SAND CREEK RESTORATION

PCD PROJECT NUMBER: CDR-20-004

PUBLIC IMPROVEMENT CONSTRUCTION PLANS

EPC STORMWATER REVIEW COMMENTS
 IN ORANGE BOXES WITH BLACK TEXT

**SAND CREEK - BANKFULL PROFILE 3
STA 22+50.00 TO 36+50.00**

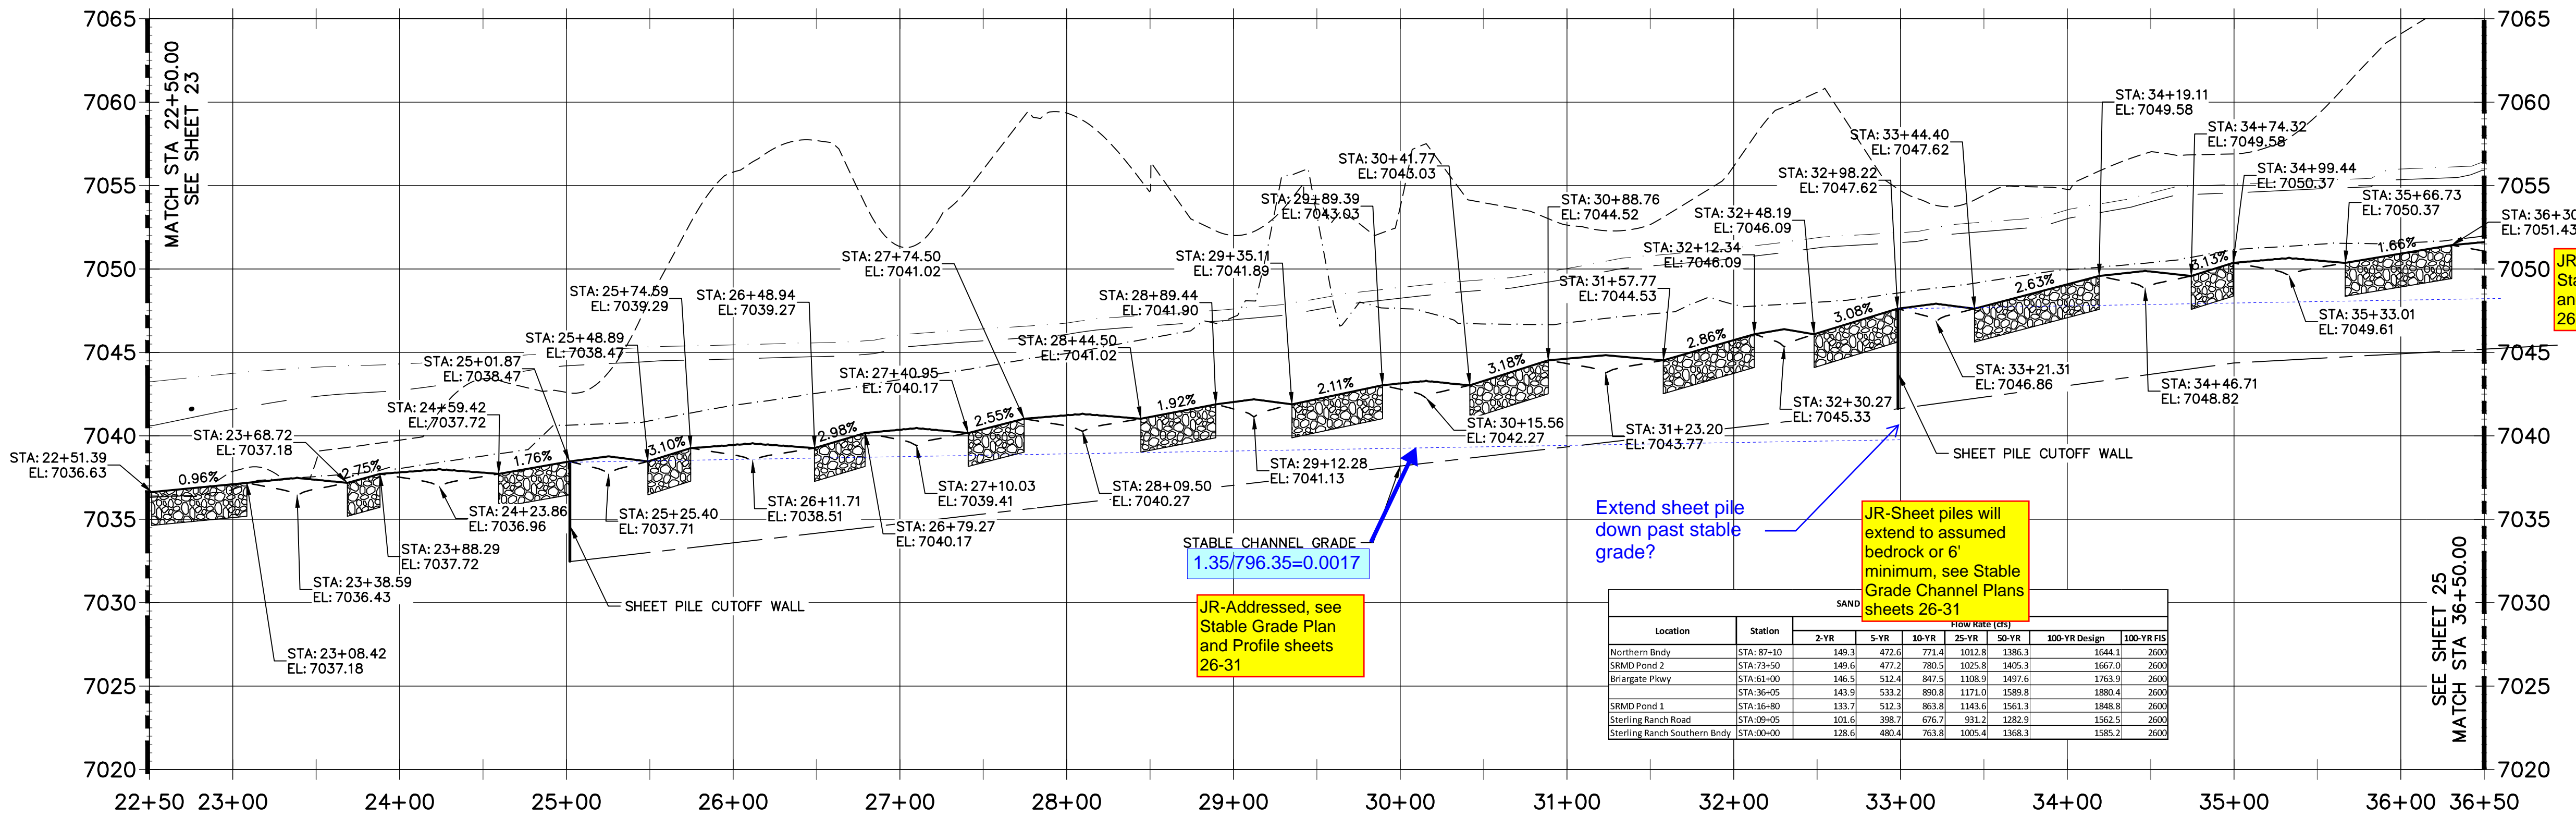
Extend sheet pile down past stable grade?

JR-Addressed, see Stable Grade Plan and Profile sheets 26-31

JR-Addressed, see Stable Grade Plan and Profile sheets 26-31

JR-Sheet piles will extend to assumed bedrock or 6' minimum, see Stable Grade Channel Plans sheets 26-31

SAND CREEK RESTORATION CHANNEL PLAN & PROFILE

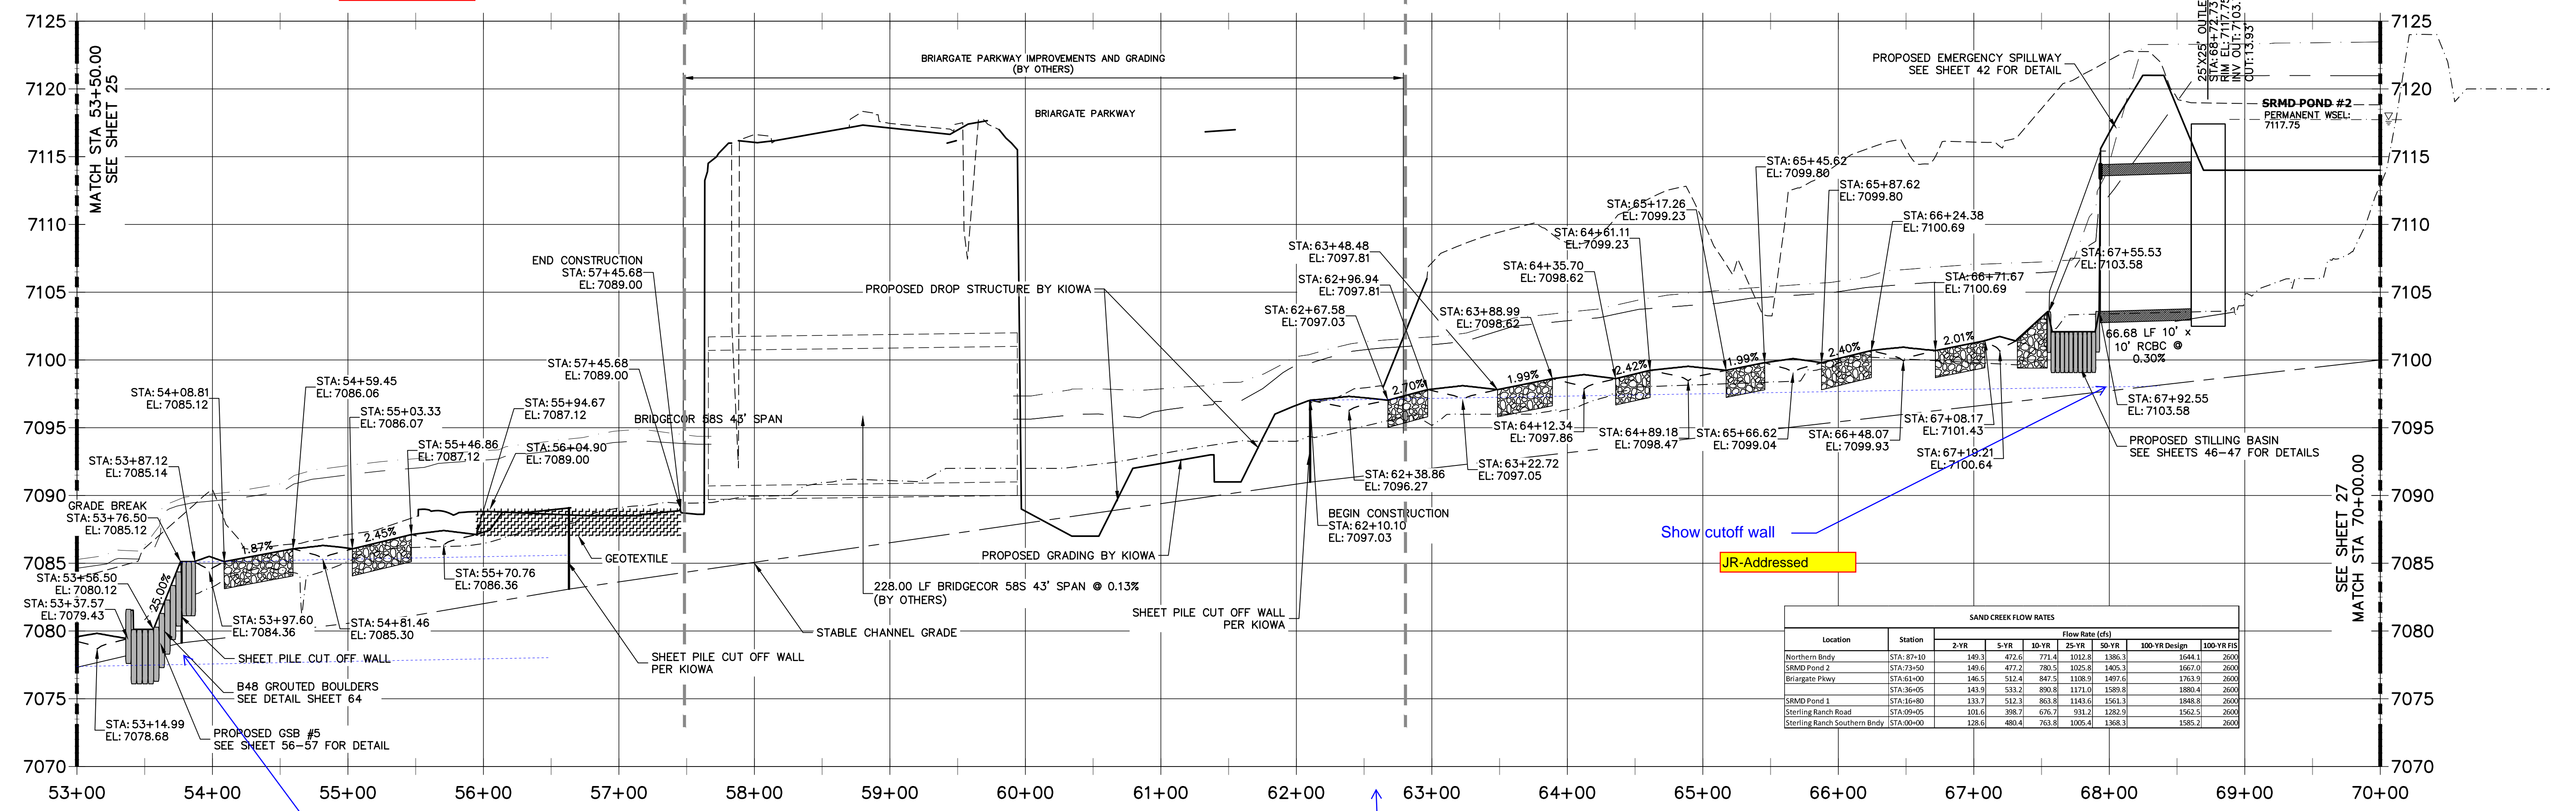
Extend sheet pile cut off wall past stable grade?

Modeling indicates supercritical flows - verify stability.

JR- Sheet piles will extend to assumed bedrock or 6' minimum, see Stable Grade Channel Plans sheets 26-31

JR-This area is going supercritical based on the changing geometry as the channel narrows heading into the drop. Soil riprap has been added in this area to reinforce it.

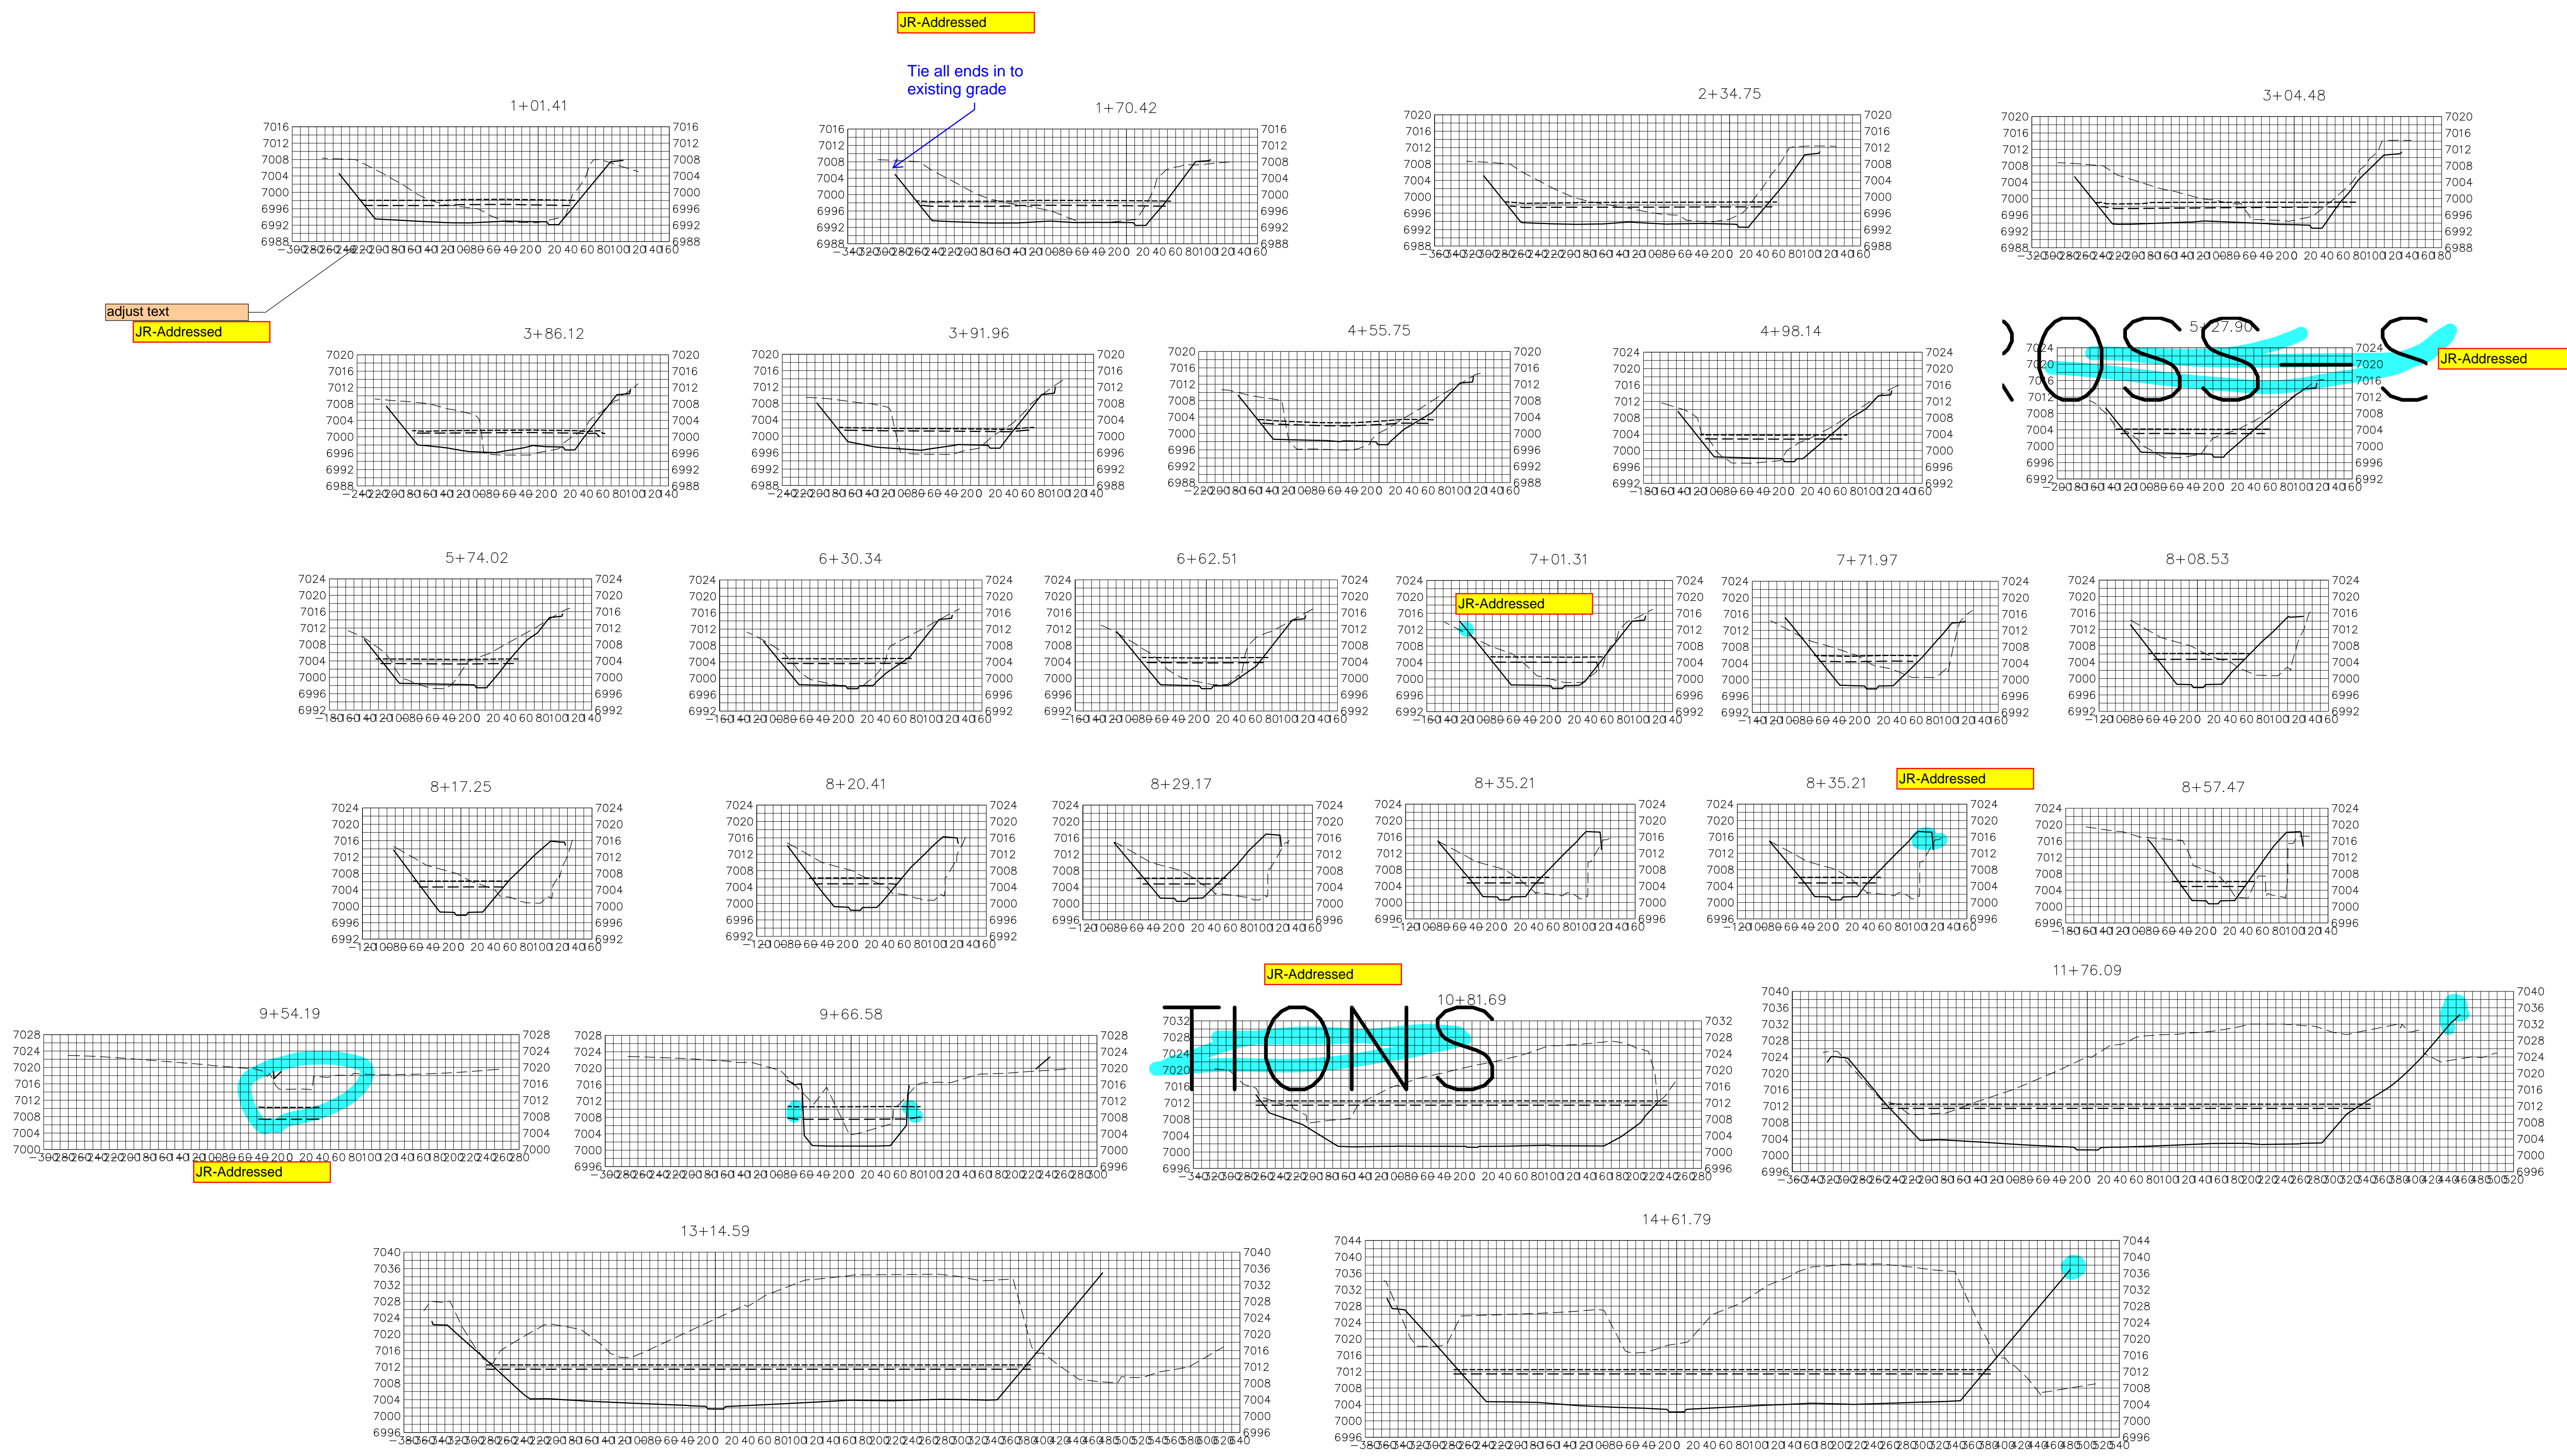
Show both maintenance roads/trail and lot lines
